UNITED STATES PATENT AND TRADEMARK OFFICE

| APPLICATION NO. | FILING DATE | FIRST NAMED INVENTOR | ATTORNEY DOCKET NO. | CONFIRMATION NO. |
|-----------------|-------------|----------------------|---------------------|------------------|
| 10/501,208 | 05/19/2005 | Steve C Benesi | SCB-03-1-PCT-US | 3477 |

| Office Action Summary | Application No. 10/501,208 | Applicant(s) BENESI ET AL. | |

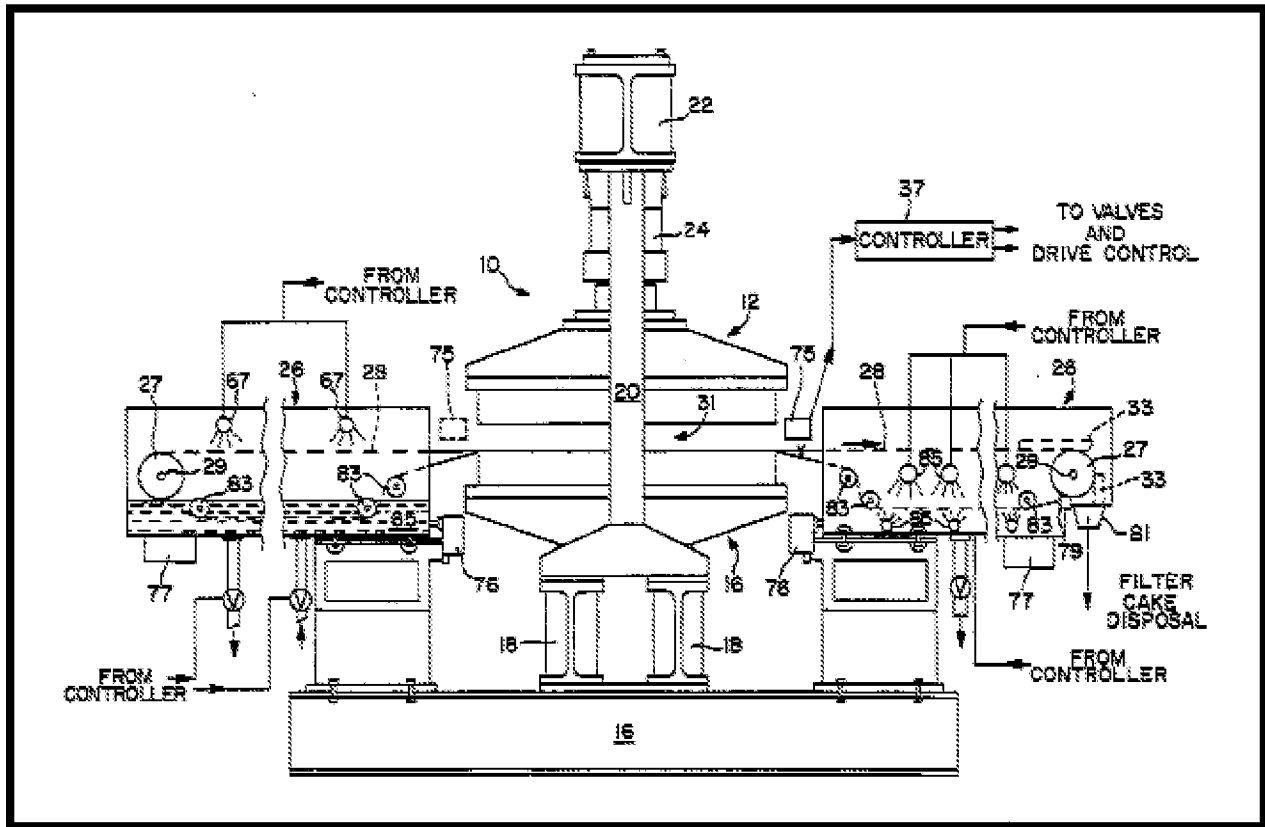
It is unclear how steps a, b, d, e and f, encircled above, can constitute “***an improvement,***” when the structure to perform these steps is admitted prior art by virtue of the Jepson claim format used.

It is unclear what Applicants intend when using the relative and subjective term **"hot"** in those claims in which it appears. Its relative and subjective nature has rendered those claims vague and indefinite, because the metes and bounds of patent protection sought cannot be ascertained.
